Edwin I. Hatch
Nuclear Plant - Unit 2

CORE OPERATING LIMITS REPORT
for
Operating Cycle 10

Revision 1

RE: Hatch Project Support - Licensing
Core Operating Limits Report for Hatch 2 Cycle 10, Revision 1
File: Fuel Cycle Technical
Log: HL-2368

FIGURE 3--2 MAPFAC_p

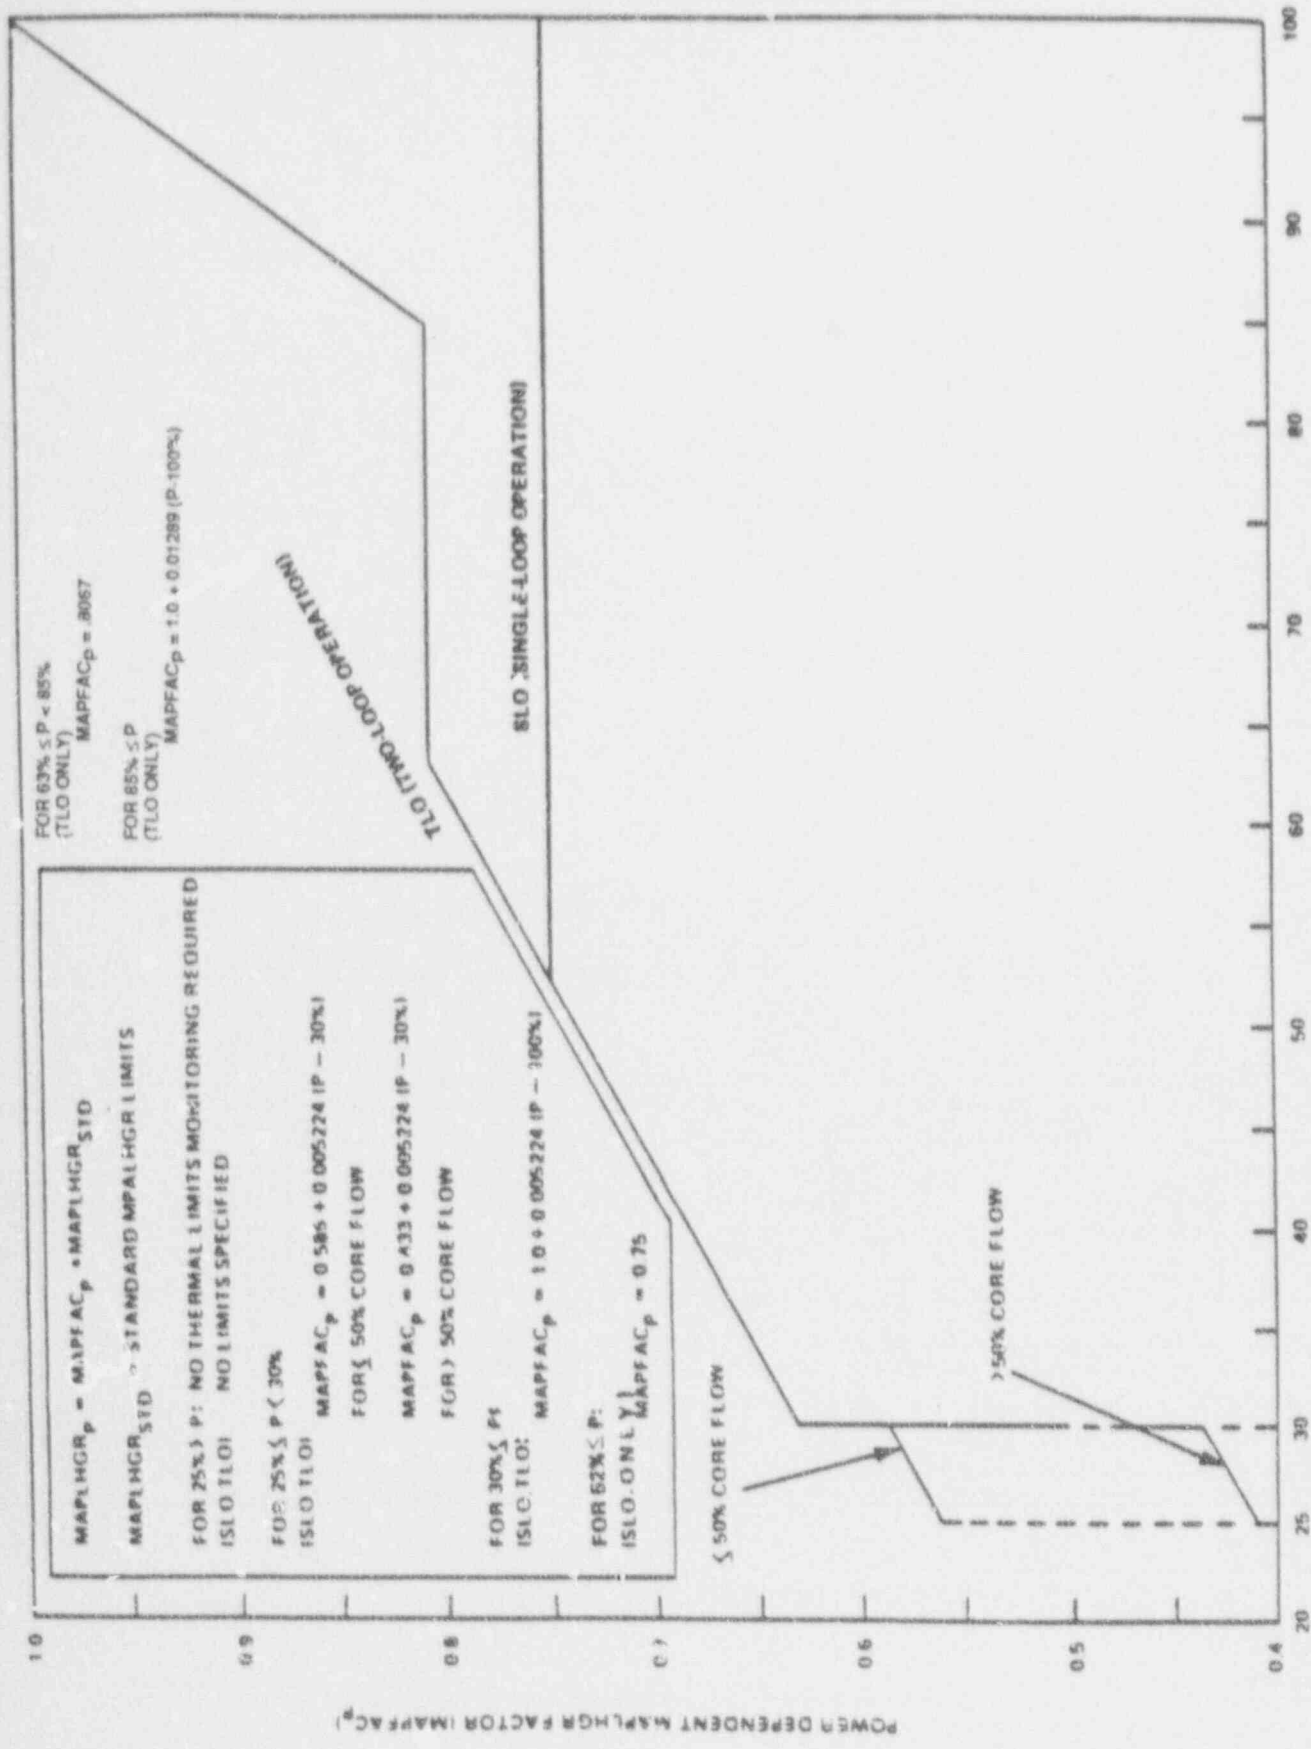
Enclosed is Revision 1 to the Plant Hatch Unit 2 Core Operating Limits Report (COLR) for Cycle 10 which imposes a Maximum Average Planar Linear Heat Generation Rate (MAPLHGR) penalty while operating above 63 percent of rated thermal power. The penalty was imposed in response to a concern related to the potential for a complete loss of feedwater heating. The MAPLHGR power factor (APFAC_p) graph in the COLR (Figure 3-2) has been revised accordingly. The concern is not applicable to Unit 1.
